Technical Preservation Services
Preservation Assistance Division
National Park Service
U.S. Department of the Interior
Washington, D.C.

Interpreting the Secretary of the Interior's Standards for Rehabilitation

Volume III

2. New floor plan after rehabilitation shows that although lightshaft has been eliminated, basic concept of "railroad flat" remains.

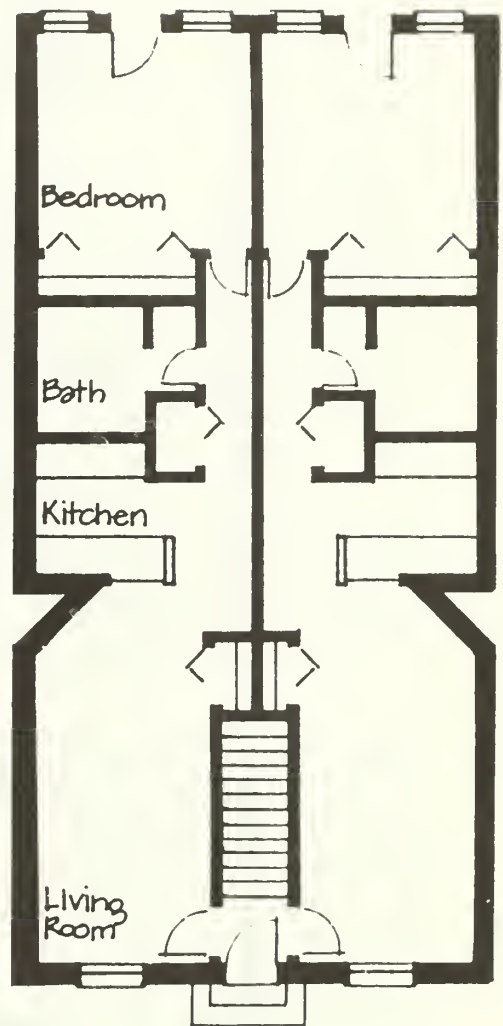
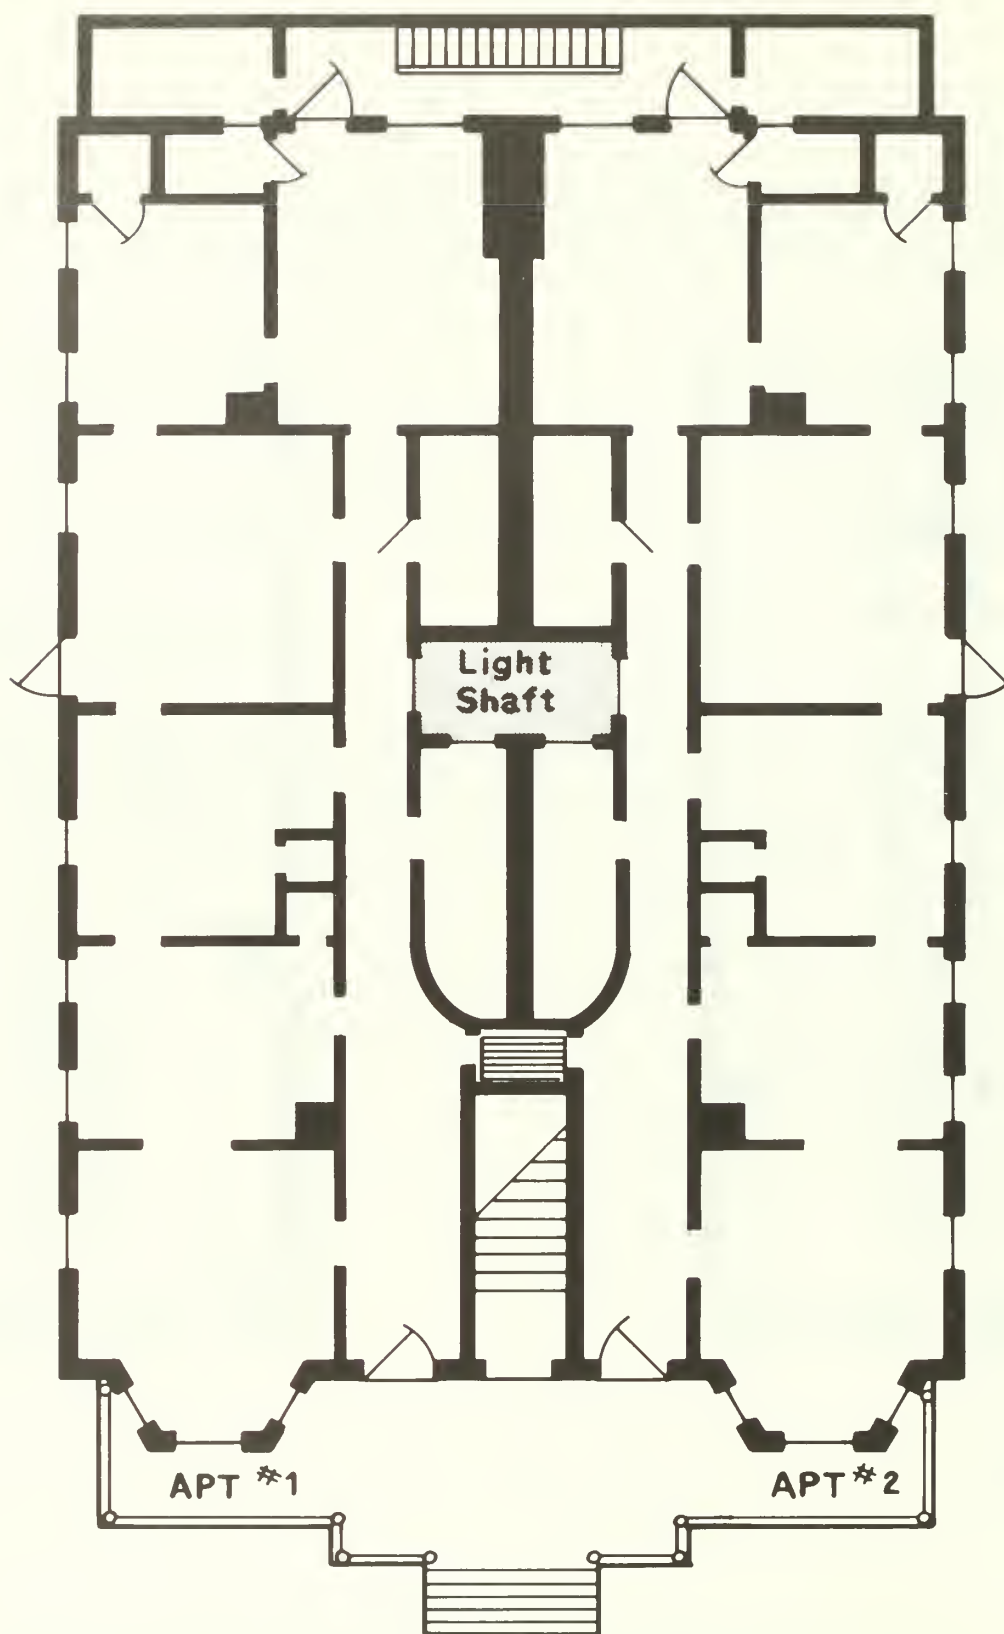
Application: A modest two-story, turn-of-the-century rowhouse which was built in 1902 originally as working-class housing, contained four "railroad" flats, two on each floor separated by a center vestibule and stair, and a lightshaft in the rear (see illus. 1). Rehabilitation plans appropriately called for the retention of the four units. However, although the basic "railroad" plans were retained for each flat (despite some relatively minor changes), rehabilitation did result in the elimination of a narrow (approximately three feet) enclosed light shaft which separated the two sets of flats (see illus. 2). The National Park Service acknowledged that the narrow light shaft had lost its function and did not meet minimum standards for light and air, but noted that this alone did not justify its removal since Department of the Interior regulations state that "the Standards take precedence over other regulations and codes in determining whether the historic character of the building is preserved in the process of rehabilitation. . ." Thus, the necessity of meeting health and safety code requirements is not a factor taken into consideration by the National Park Service in its review of a rehabilitation project. More importantly, the National Park Service determined that obliteration of the lightshaft did not result in significant changes to the floor plan, nor did it alter the character-defining features of the exterior. The "exterior continues to contribute to the significance of the historic district in which it is located, and the interior still preserves its original center-entrance plan." In short, the rehabilitation was determined to be in conformance with the Standards because "those components that are important in defining its character have been retained."

3 and 4. Before rehabilitation floor plans of 1900 building (left) and 1890 building (right).

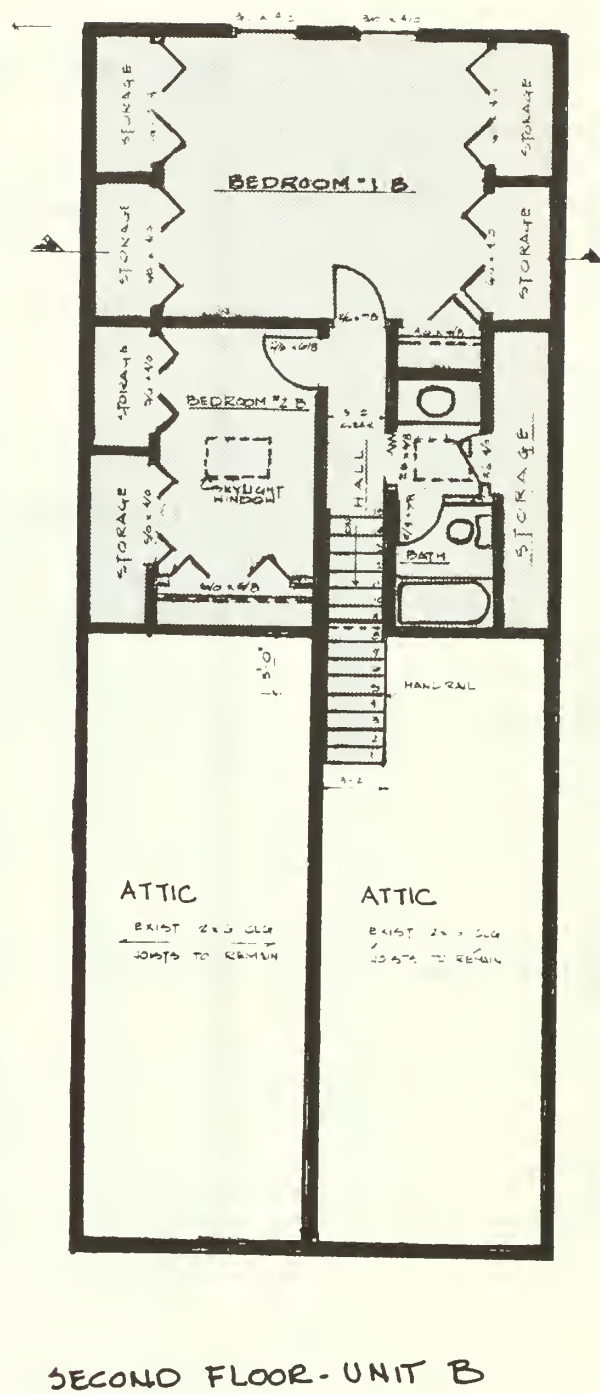
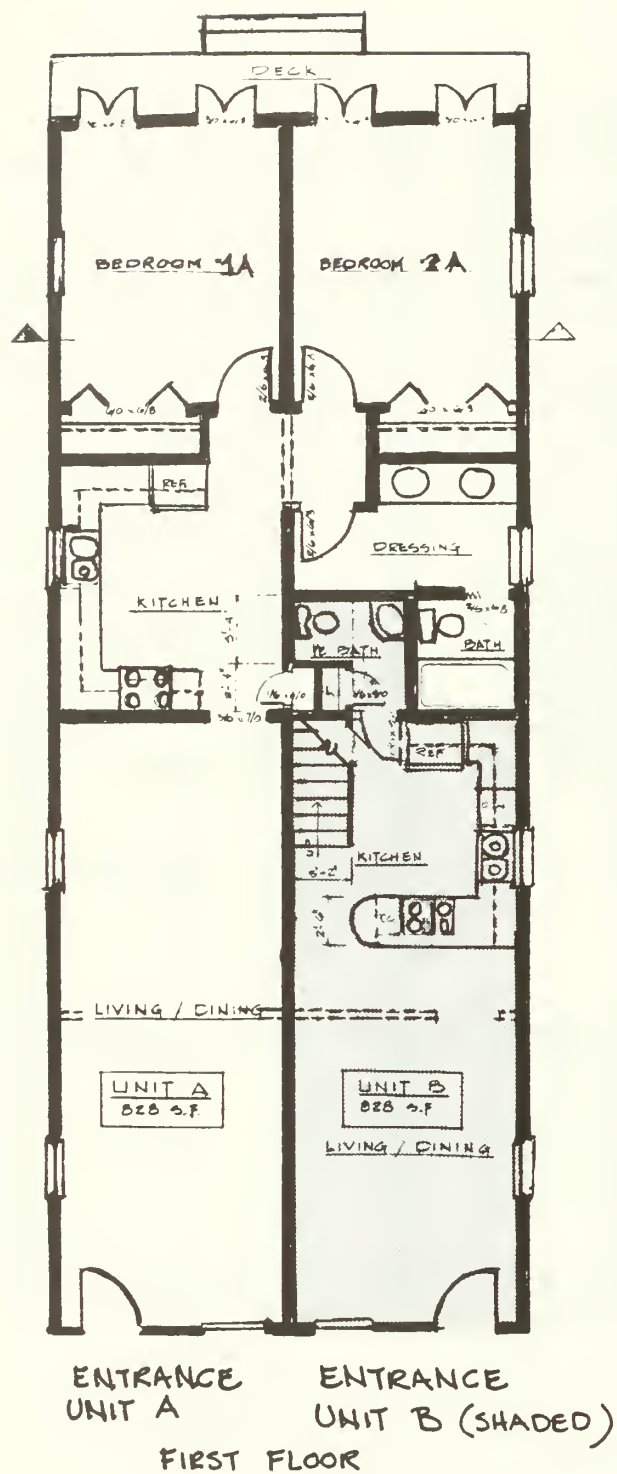
In the first case, the "shotgun" plan was generally retained in the rehabilitation with some modifications (see illus. 5). Kitchens were inserted into the second room of each half of the duplex; a bathroom and laundry were inserted into the third room. The fourth room in each half of the building was enlarged by moving the partition forward a few feet. Despite these alterations, the division of the building into two equal units was respected in the rehabilitation. Within each half of the double cottage, the interior arrangement of small rooms, one behind the other, was also maintained. Thus, on both the exterior and the interior, the building appears as it appeared historically, as a modest double cottage in the "shotgun" style. This plan largely determined its historic character, which remains following the rehabilitation. The project meets the "Standards for Rehabilitation."

In the second case, radical changes made during the rehabilitation obliterated the characteristic interior plan (see illus. 6). The separation between the two front rooms was destroyed to create one larger room in place of the double parlor arrangement. In

2. Plan of lobby (A), adjoining palm room (B) and dining room (C) before rehabilitation.

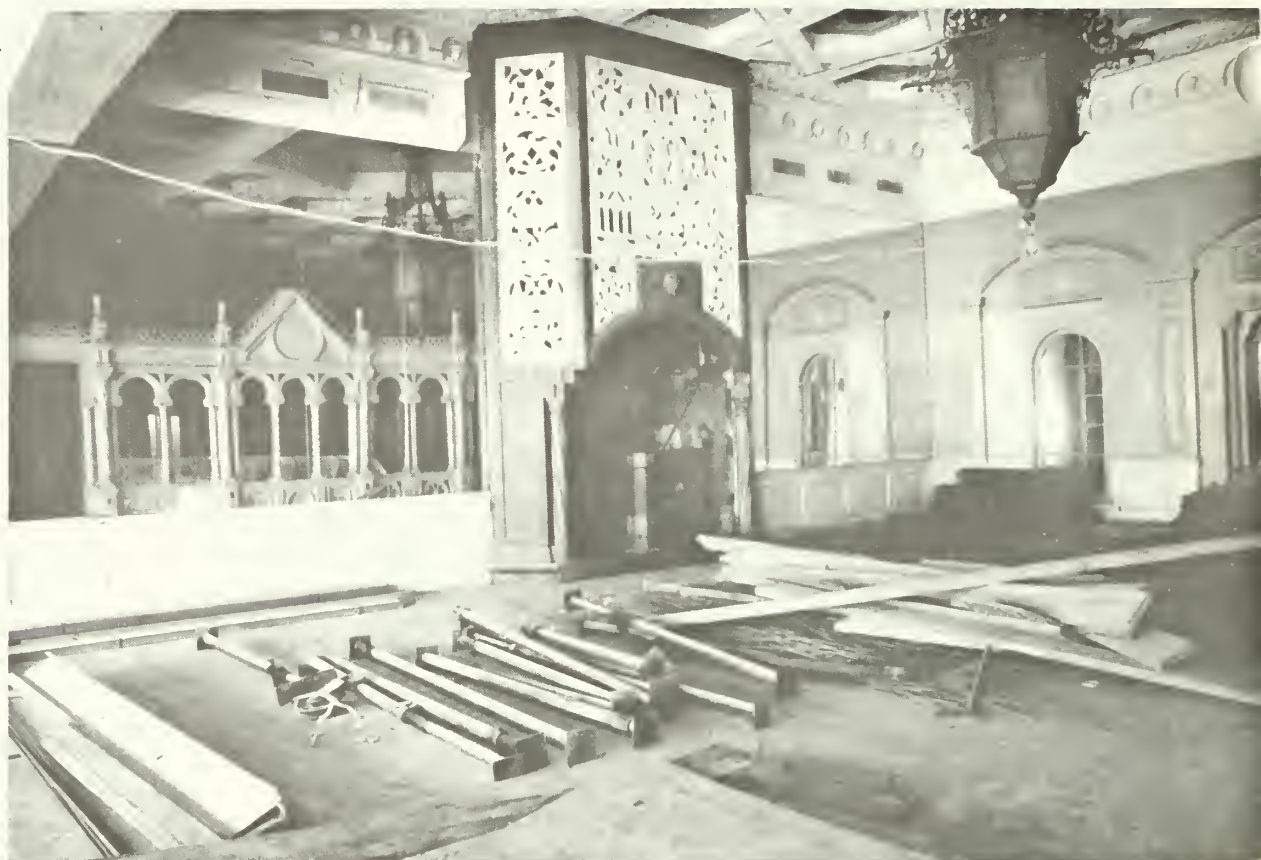
The project was determined not to meet the "Standards for Rehabilitation" on a number of grounds. In the palm room both the decorative finishes and the space itself were destroyed in the process of inserting two levels of residential space. In the dining room, individual features were retained, but in the finished work they appear as individual artifacts only, out of architectural context. The sense of the room as a coherently organized space is lost. These modifications to the two spaces had adverse effects on the historic character of the building, and alone would preclude the project from meeting the Secretary's Standards. When these spaces are viewed in relation to the overall layout of the building, however, the consequences caused by their subdivision appear even more serious.

The insertion of a solid partition behind the open screen effectively cut off the lobby from the palm room. The damage wrought by the rehabilitation to the individual spaces thus exceeded the demolition of individual features or their incorporation into smaller rooms. The rehabilitation destroyed the formal organization of the spaces themselves. The progression from the grand, three-story lobby, up the elaborate split stair into the palm room and adjoining dining room was lost, and the historic character of the building irreparably harmed.

2. After rehabilitation and installation of the new windows, the "eyebrows" seem to float--disconnected--above the dark brown fixed sash.

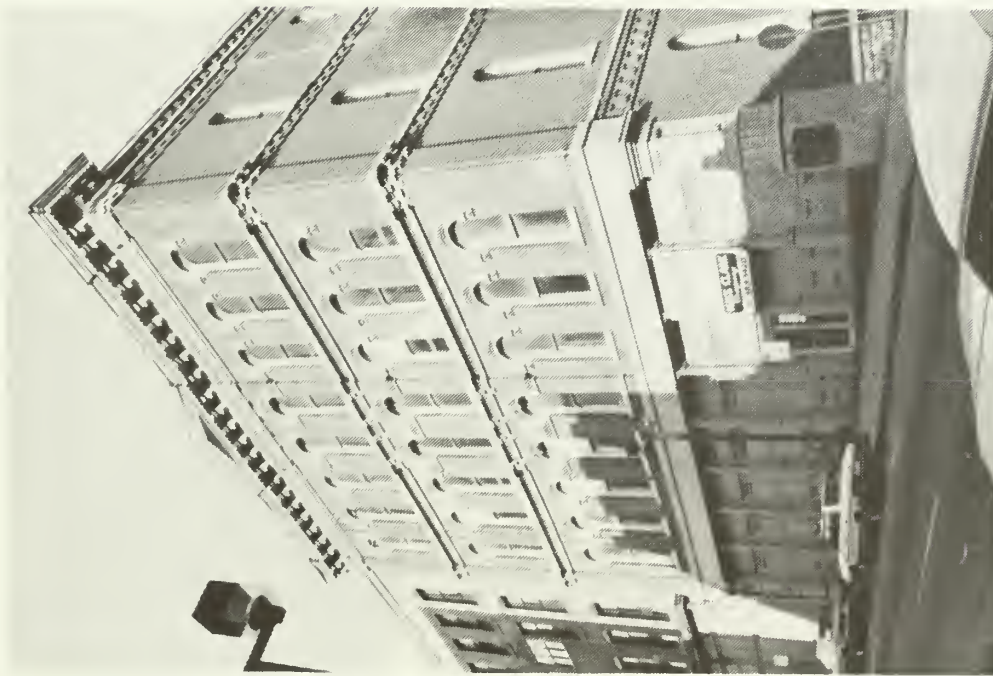
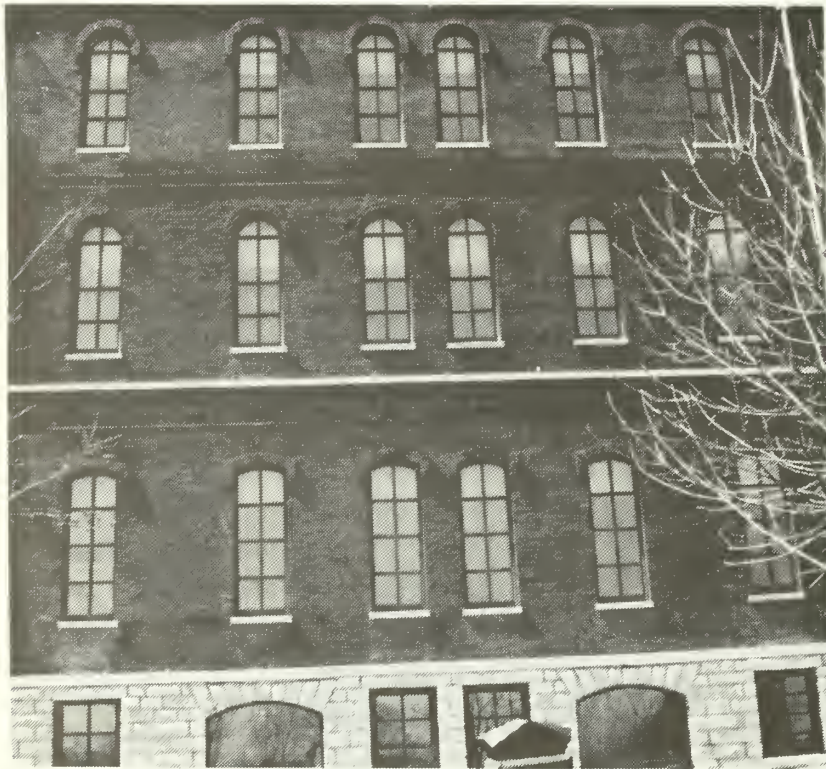
Before and after photographs revealed several design deficiencies in the new window. Where one over one double-hung windows had existed historically on the building's primary facade, the replacement windows were a "fixed" design with both upper and lower sash on the same plane; the horizontal piece applied as a meeting rail is actually flat, and consequently unable to cast the familiar shadow line of the historic window. Finally, there was a dramatic difference in color, from a light cream color to dark brown (see illus. 1 and 2). On another key facade, where there had been historic four-over-four double-hung windows, fixed sash were installed, the light divisions were altered, wider muntins were used, and the color of the windows was changed (see illus. 3, 4 and 5).

FRAME ELEVATION

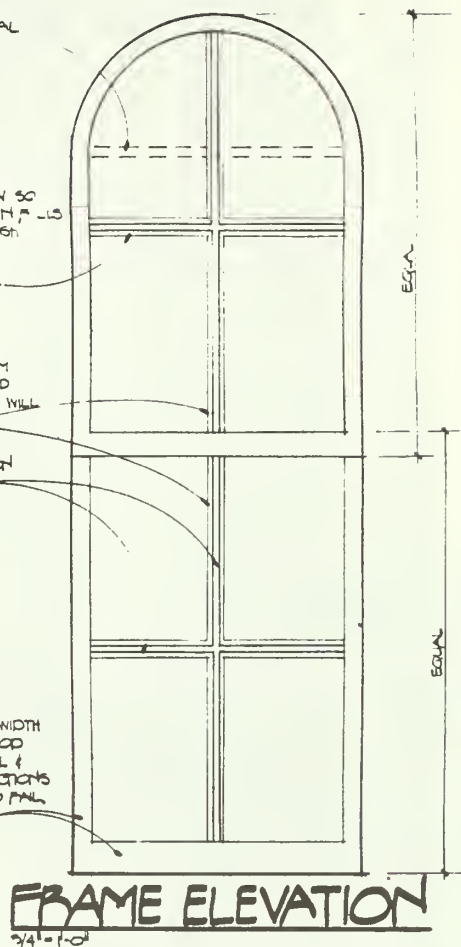
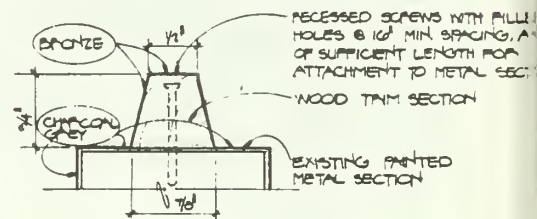
6. In an attempt to bring the inappropriate four-over-four replacement units (see 4 and 5.) into conformance with the Standards, two alternatives were proposed. In proposal A, the horizontal muntin at the top would be relocated so that all eight lights would be of equal size like the original. A 3 1/2" wide aluminum strip would be applied in an attempt to recapture some aspects of the meeting rail. Even after these adjustments, however, the upper and lower sash would read as a single, fixed unit; the muntins are also too wide and too flat.

7. In alternative B, proposed changes included installation of a wood brick molding. In an attempt to make the muntin appear thinner and visually recessed, the wide aluminum muntins would be painted a charcoal gray; trapezoidal shaped wood strips would also be applied to the existing flat muntin and painted to match the existing window color. Even making these modifications, the replacement window did not match the detailing of the historic window--the depth of the frame and muntin was still far too shallow, and the muntin profile and width was still inappropriate. This proposal was also rejected.

REMOVE TOP HORIZONTAL
MUNTIN & GLASS

APPLY WOOD TRIM SECTION
TO PAINTED MUNTINS

APPLY 3/4" THICK x FULL WIDTH
(OF EXISTING SECTION) WOOD
SECTIONS TO HORIZONTAL &
VERTICAL PERIMETER SECTIONS
& TO HORIZONTAL MEETING PAIR
COLOR TO BE BRONZE

6. Shop drawing showing applied muntin grid projecting beyond the exterior surface of the sash. Also note rectangular shape and the two grooves on the interior and exterior muntin grids which produce the ribbed appearance and additional shadow lines that did not exist on the historic windows.

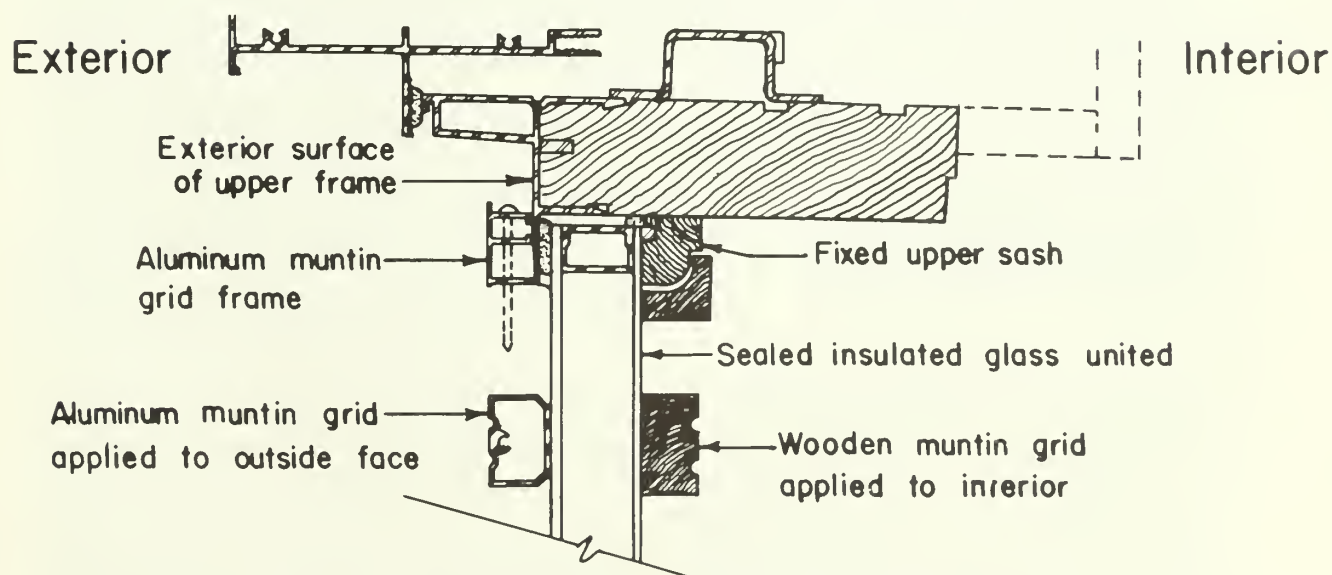
The thickness of the meeting rail so evident in the historic sash has been reduced in depth creating a weaker shadow line (see illus. 5). The use of an applied aluminum muntin grid rather than true 16-over-16 wood muntin divisions has caused significant changes to the appearance of the windows (see illus. 6). The muntin grid clearly does not match the original, since the new muntins have a rectangular rather than trapezoidal profile, it has a ribbed surface, and it extends beyond the plane of the rails and stiles. The projecting grid, furthermore, creates additional shadow lines that did not exist on the historic windows. The historic muntins were flush to the surface of the sash, integral to the sash frame construction and trapezoidal in shape after puttying.

9. Drawing of proposed window and original window and frame location. Note how new sash and frame are set closer to the exterior and within the window opening. The owner's alternative panning identified above will not correct the deficiencies of the sash.

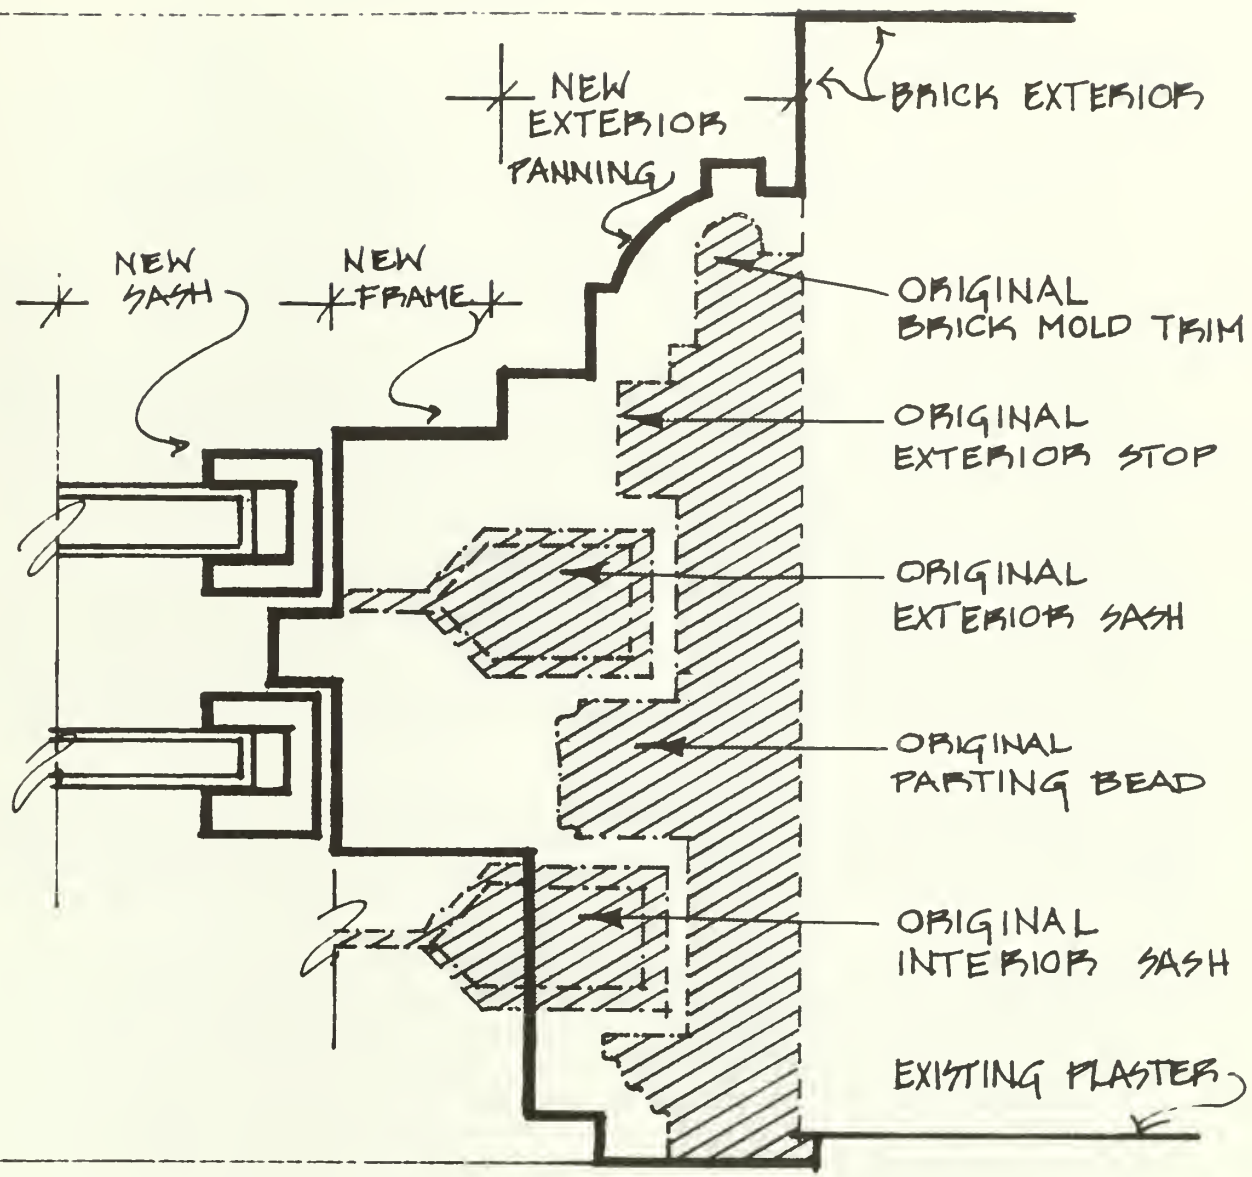
8. Proposed replacement windows on third floor and original windows below. Note how dark sash and frames are unobtrusive, light sash and frames create a striking pattern on the red brick facade.
